P&Z STAFF REPORT

Board of Appeals Hearing; August 10, 2017

Case: **V17-0030 – 5965 Riverside Drive**

P&Z STAFF REPORT

SITE PLAN (FULL SITE PLAN AS ATTACHMENT)

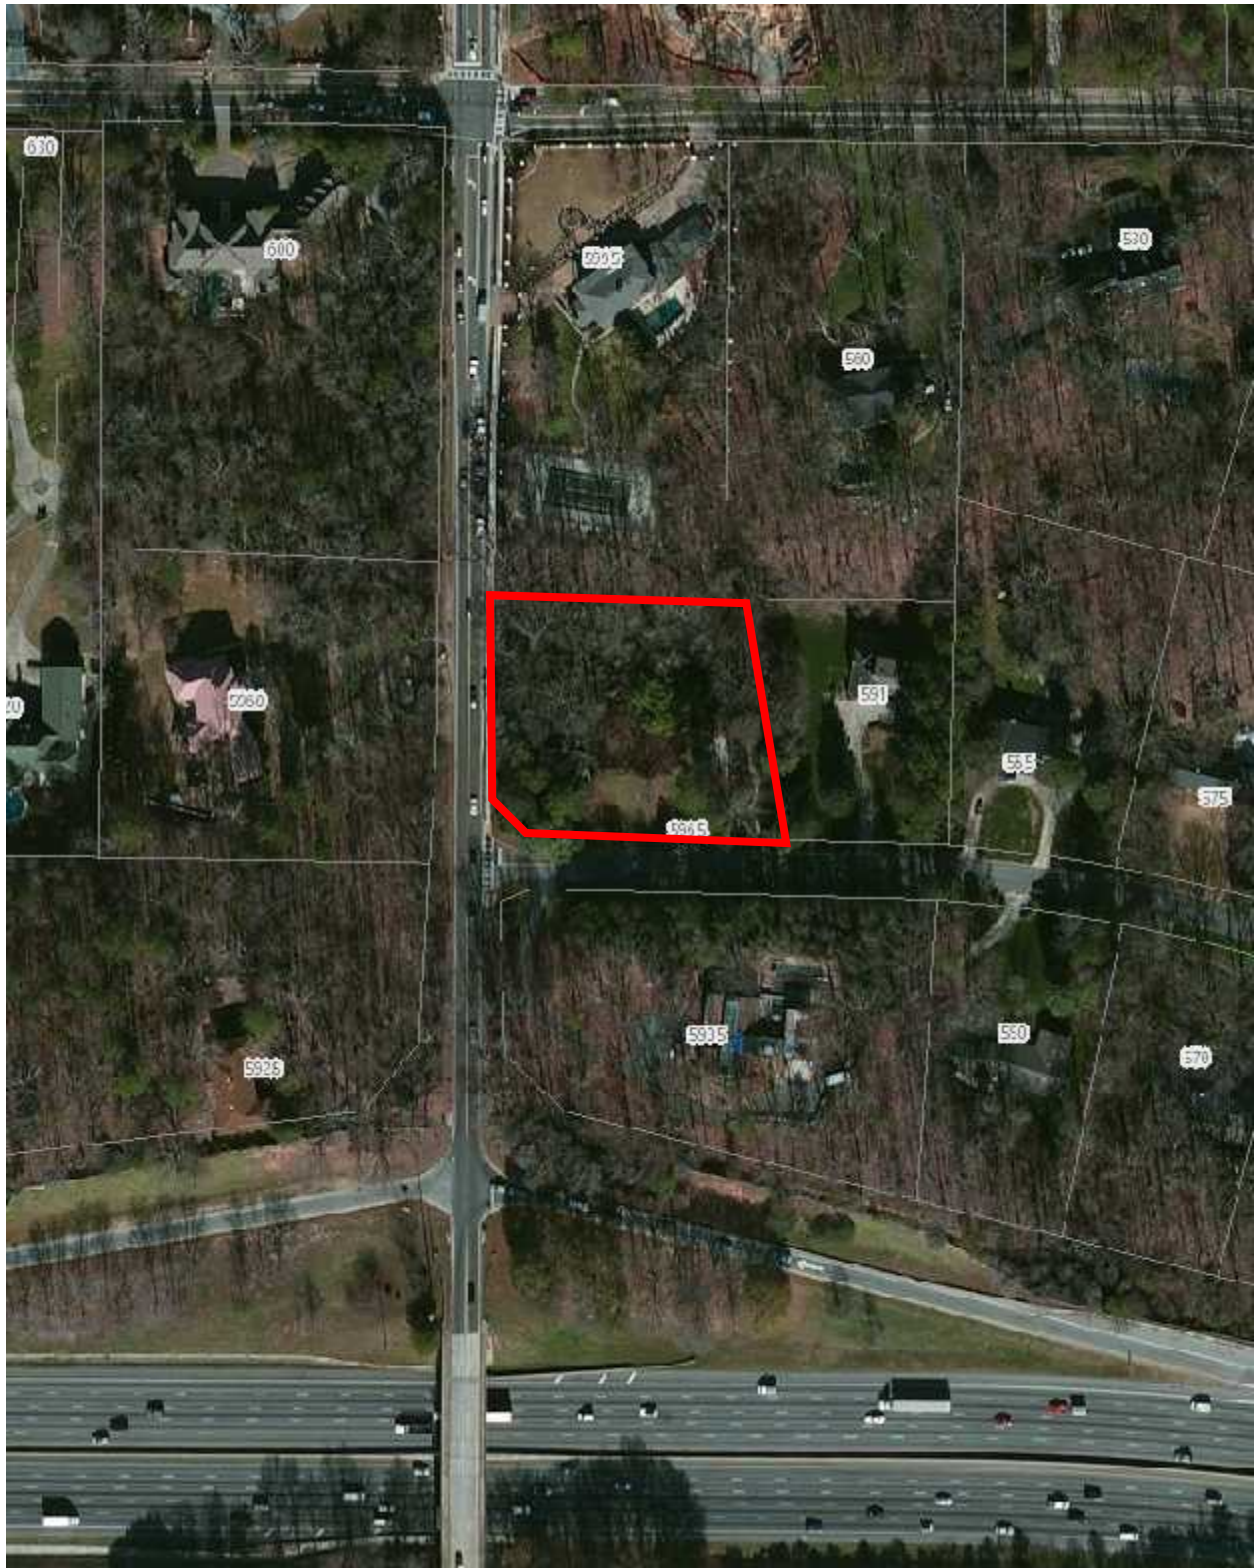
Finding: The subject parcel is a corner lot on Riverside Drive and Coldstream Court, and has Heards Creek roughly run along the northern property line. In 2014, the applicant applied for a building permit to construct a single-family detached house without encroaching into the stream buffer or the additional impervious surface setback. Eventually, the applicant began construction in 2016. During construction, a City Inspector noticed the placement of silt fencing outside of the approved limits of disturbance, and warned the applicant to stay outside of the stream buffer. The applicant failed to comply with the approved plan set and the City Inspector's warning, and subsequently installed the three rock walls in their present location.

The site is steep, with a 20 to 30-foot drop-off from the rear yard to the stream. While the site is presently stabilized, removing the rock walls would leave a steep open slope, which would lead to soil erosion into the stream and diminish water quality. Therefore, Staff finds that removal of the three rock walls would create a less desirable outcome, increasing the possibility of negatively impacting the stream.

At 331 square feet, the encroachment into the stream buffer and impervious surface setback is small. The design of the rock wall allows water to infiltrate partially into the soil beneath. In addition, the applicant proposes to revegetate the buffer area and the level areas between the rock walls. The vegetation will

1. To allow three recently constructed retaining walls to remain, as shown on the site plan prepared by Frontline Surveying & Mapping, Inc., dated May 2, 2017, and received by the Department of Community Development May 22, 2017, to remain.

SITE PLAN (FULL SITE PLAN AS ATTACHMENT)

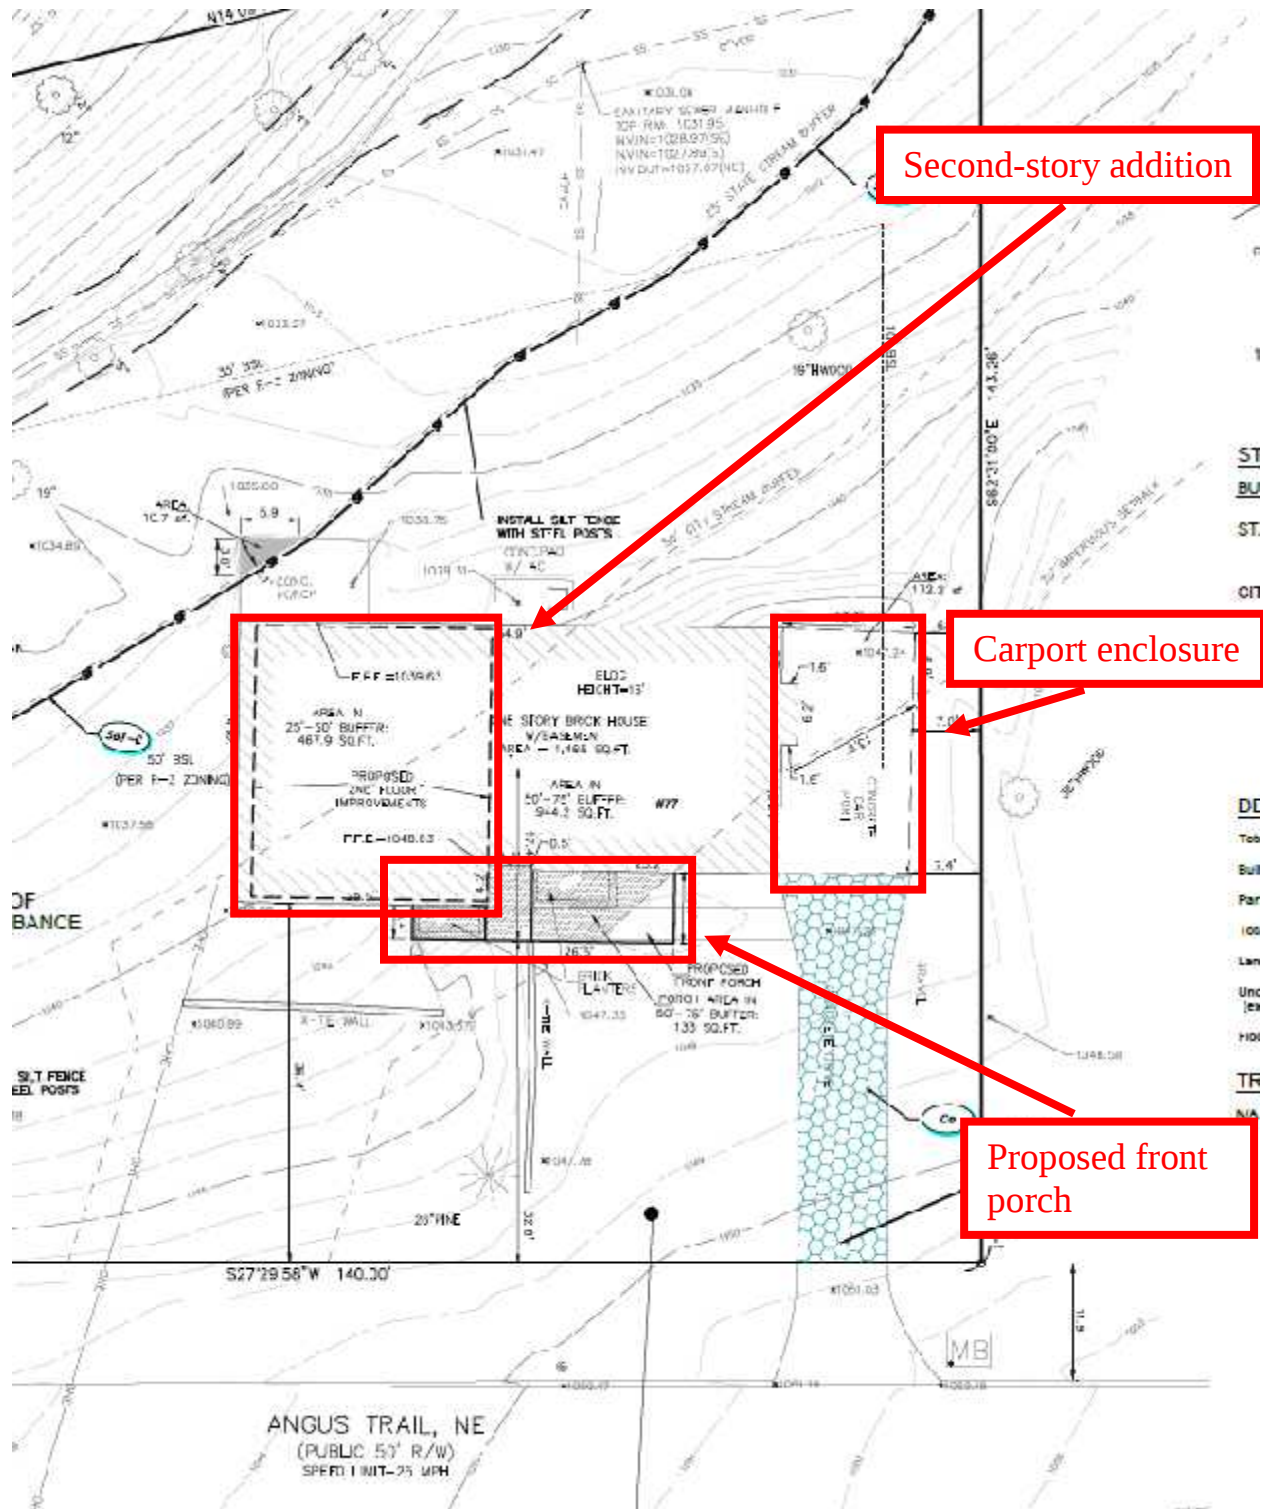
For historic reasons unknown to Staff, and not caused by the current property owners, the existing structure encroaches up to 13.6 feet into the 50-foot minimum front yard and up to 3.3 feet into the 10-foot minimum side yard. The second-floor addition and the carport enclosure will be entirely within the existing footprint. The proposed front porch would be an additional 3.4 feet closer and be 32.6 feet from the front property line.

The front porch, would add 133 square feet of additional impervious surface in the additional 25-foot impervious surface setback (75-foot setback) with no additional encroachment into the 25-foot State or

50-foot City stream buffer. Since the encroachment is small and on the far side of the house from the stream, Staff anticipates limited impacts on the stream water quality.

1. To allow the construction of additions to an existing residence, as shown on the site plan prepared by Atwell, dated June 27, 2017, and received by the Department of Community Development July 6, 2017.

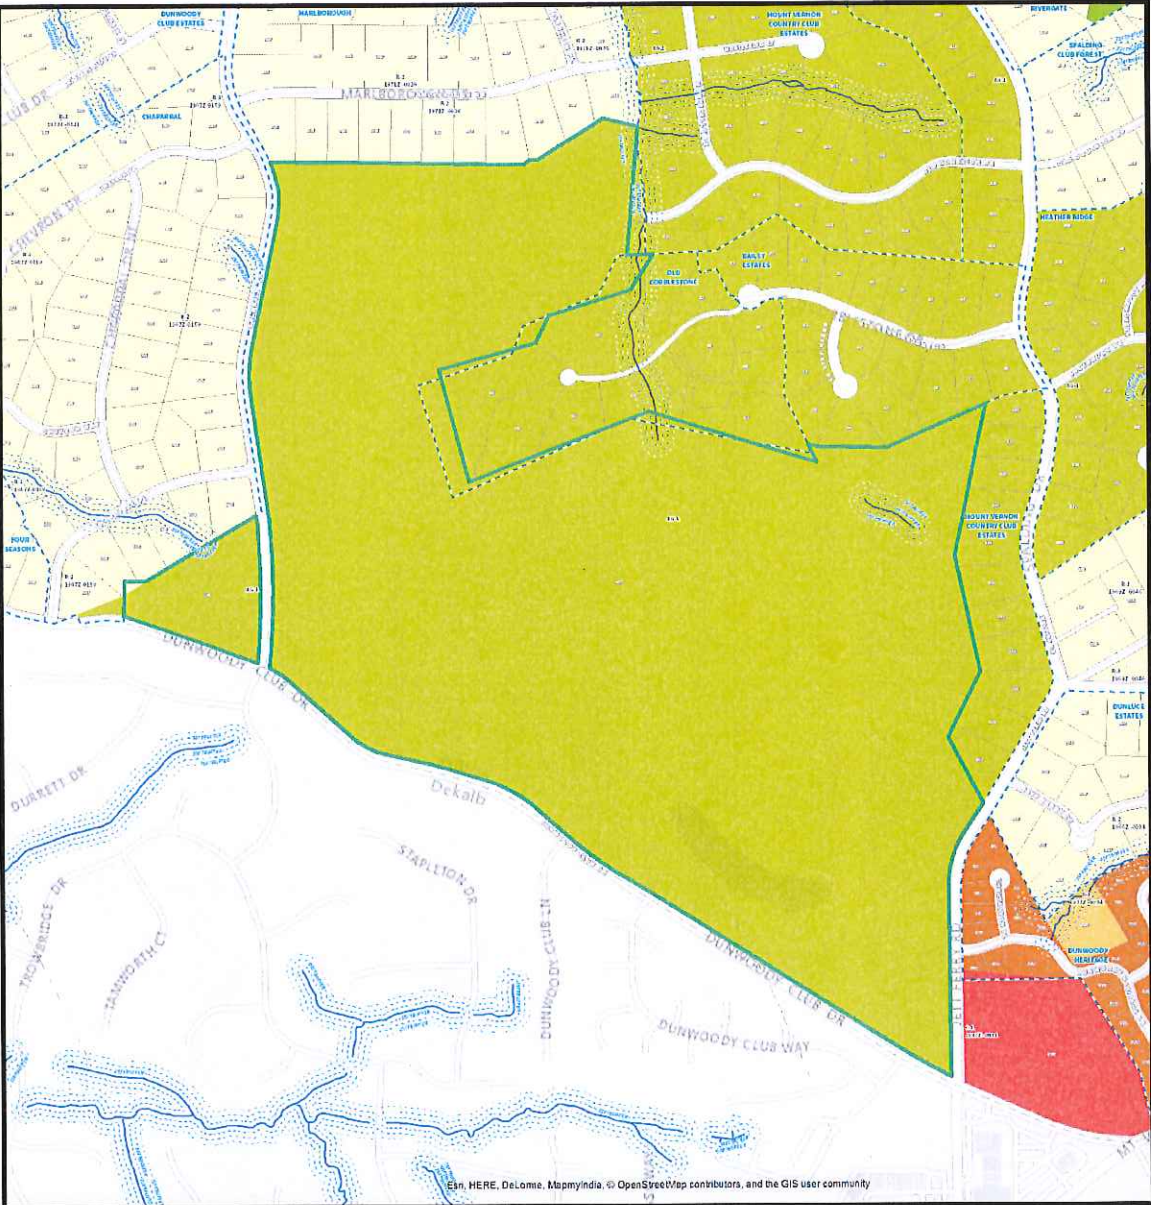
The existing Dunwoody Country Club and accessory uses pre-date the City's Land Development requirements and is well established within the community. The requested Variance would allow the applicant to expand a parking lot that encroaches approximately 95 feet into the required 100-foot setback and 50-foot buffer adjacent to Dunwoody Club Drive. Site improvements include the clubhouse, swimming pool and tennis courts and several parking areas, which have existed for many decades. It is noted that tennis courts and parking areas are currently located within the required 50-foot buffer and 100-foot setback and approximately as close as five feet from the property line. Although there are several parking sections on the property, expanding the proposed parking area seems to be the most logical extension. Two of the parking sections are closer to residential lots and the other two are restricted by either existing improvements or the golf course. The existing parking area has coexisted in the community for several years and extending the parking lot along the roadway for approximately 120 feet could be appropriate if proper conditions are incorporated to ensure compatibility with nearby residential neighborhoods. There is a row of hedges and a fence that screens the parking lot from the roadway. Extending this row of hedges and fence if necessary to screen the expanded parking lot would assist in addressing any visual adverse impacts on residences across the street. The requested parking lot expansion would be considered relatively small and with mitigating conditions, would not be expected to adversely impact the

residences across Dunwoody Club Drive. The existing Country Club and accessory uses seem to be compatible with the residential community and the Variance would allow minimum relief for the additional 37 parking spaces. Approval of the Variance would be consistent with the general intent of the zoning ordinance and would not be expected to be detrimental to the public good, safety, and welfare. Therefore, staff recommends approval conditional of the Variance request.

SITE PLAN (received July 31, 2017)

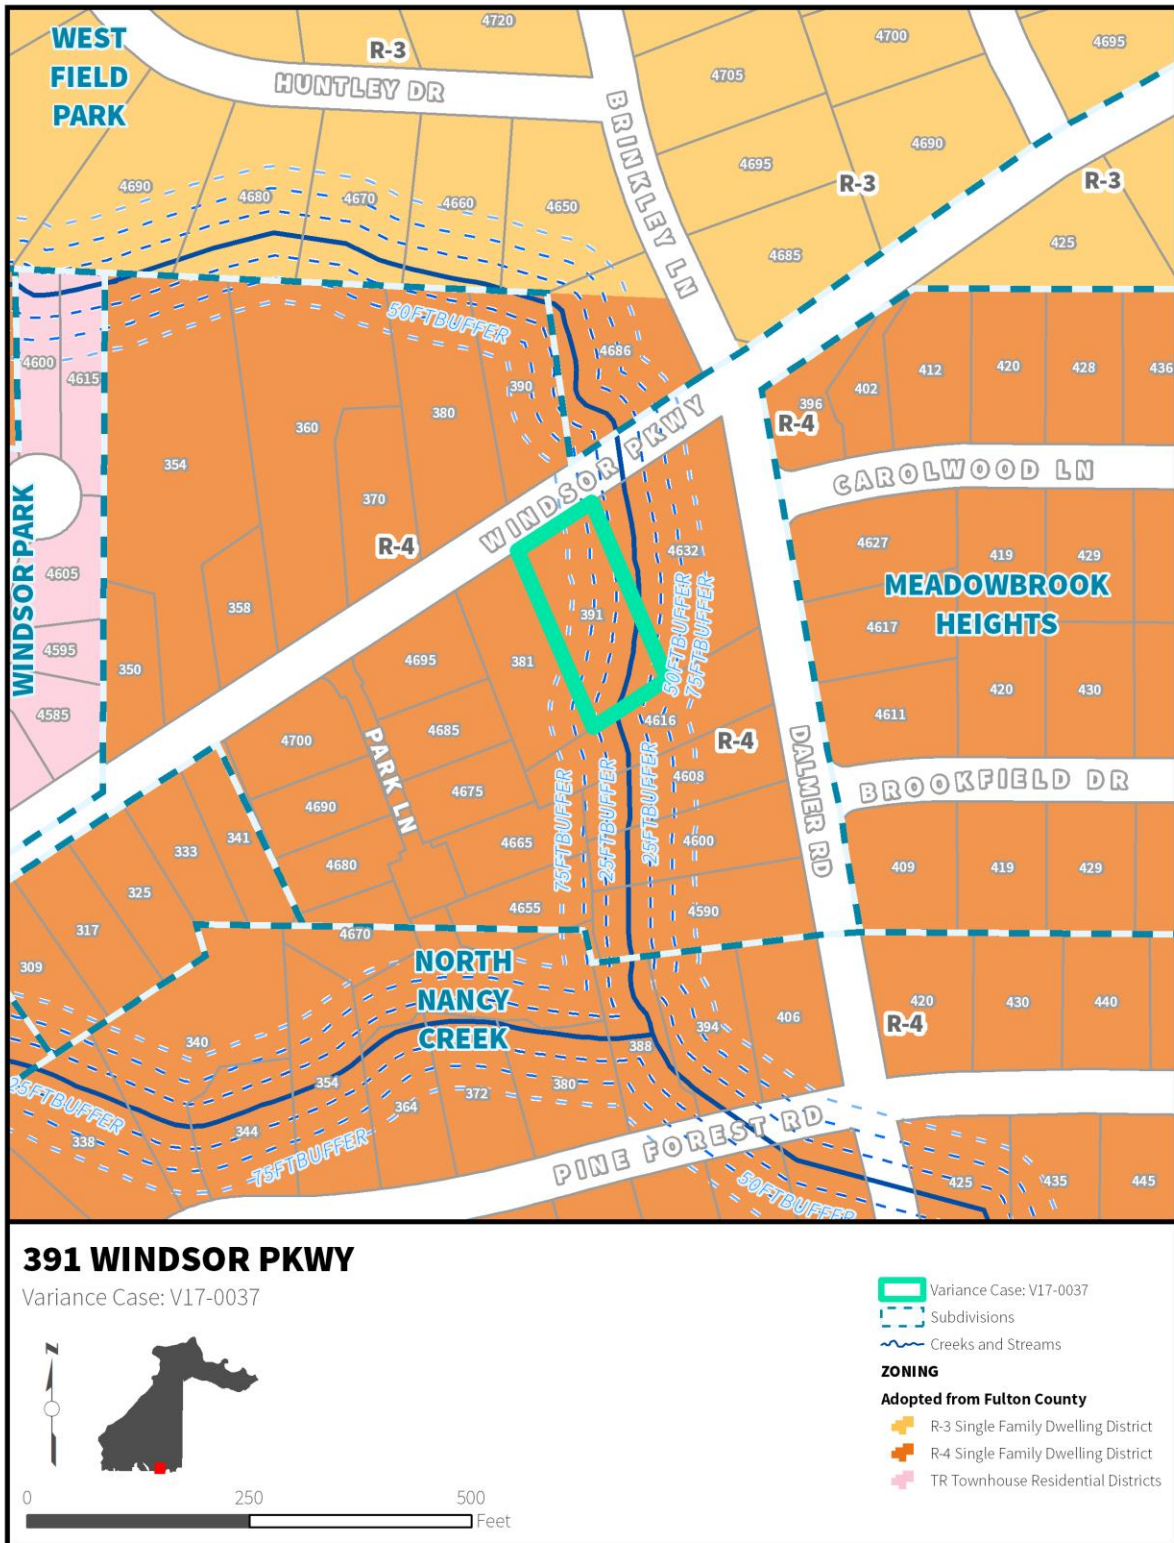
The applicant requests a stream buffer variance to remove the existing house and construct a new single family residence on the site. The applicant proposes a two (2) story residence with basement, garage, wood deck, driveway, paver walkway, walls, and stone storage infiltration trench that collects roof downspouts. The applicant intends to keep the existing concrete abutment/wall, retaining wall, and some pavement to the west of the concrete abutment/wall but not in the buffers. The proposed house would encroach into the 50' undisturbed natural vegetative buffer and additional 25' impervious surface setback but be set back farther from the stream than is the existing house.

Specifically, in the 25' State stream buffer, the applicant proposes to remove existing impervious area, keeping some pavement to the west of the concrete abutment/wall but not in the buffers. In the 50'

stream buffer, the applicant proposes a small encroachment for the proposed house and wood deck and to remove existing pavement area. In the 75' setback (the additional 25' setback), the applicant proposes encroachment for the proposed house, wood deck, garage, driveway, paver walkway, and stone storage infiltration trench and to remove existing pavement area.

As shown in the table below, the total area of increased encroachments into the buffers would be 141 square feet from 0'-25', 218 square feet from 25'-50', and 1,082 square feet from 50'-75'. The total area of impervious area encroachments would be a decrease of 489 square feet from 0'-25', a decrease of 1,025 square feet from 25'-50', and an increase of 58 square feet from 50'-75'.

1. To allow encroachment into the 50' undisturbed natural vegetative buffer and additional 25' impervious surface setback to remove the existing house and construct a new single family residence, as shown on the "*Site Plan for: Mr. Shawn McAleer, 391 Windsor Parkway,*" Sheet S-1, by Engineering 303 Stream Restoration, prepared, signed, and sealed by Zachary C. Truelove, P.E., dated August 22, 2016, last revised July 28, 2017, and received by the Department of Community Development on July 31, 2017. Said site plan is conceptual only and must meet or exceed the requirements of the Zoning Ordinance and these conditions prior to the approval of a Land Disturbance Permit. Unless otherwise noted herein, compliance with all conditions shall be in place prior to the issuance of the first Certificate of Occupancy.
